Access Compliance Report

Public Rights-of-Way

(Pedestrian Signals)

Intersection ID: N/A	Main Street:	Cross Street: N/A	Location: N/A
ADA ID: 95E9D8DBEF86	Signal Type: One Push Button-Non APS	Overall Compliance: No	Severity Score: BTN 1: N/A BTN 2: N/A No BTN: N/A
Codes/Mitigation Info/Possible Solution		Field Measurements/Component Compliance

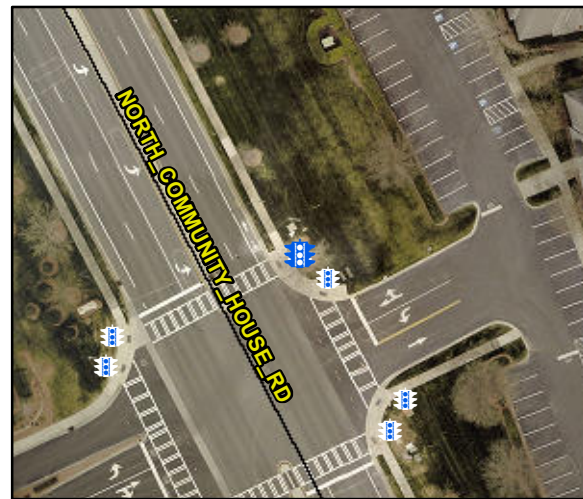
Yes	B 1 Clear Xing Direction?	ClearlyMarked	N/A	B 2 Clear Xing Direction?	N/A
	B 1 Crossing Direction	To SW		B 2 Crossing Direction	N/A
Yes	B 1 DistanceTo XWalk (in)	4.0	N/A	B 2 DistanceTo XWalk (in)	N/A
No	B 1 DistanceTo Curb (in)	96.0	N/A	B 2 DistanceTo Curb (in)	N/A
Yes	B 1 Diameter (in)	2.0	N/A	B 2 Diameter (in)	N/A

Possible Solutions: Replace Signal Push Button With APS Button on New Post. Remove & Relocate Sign.
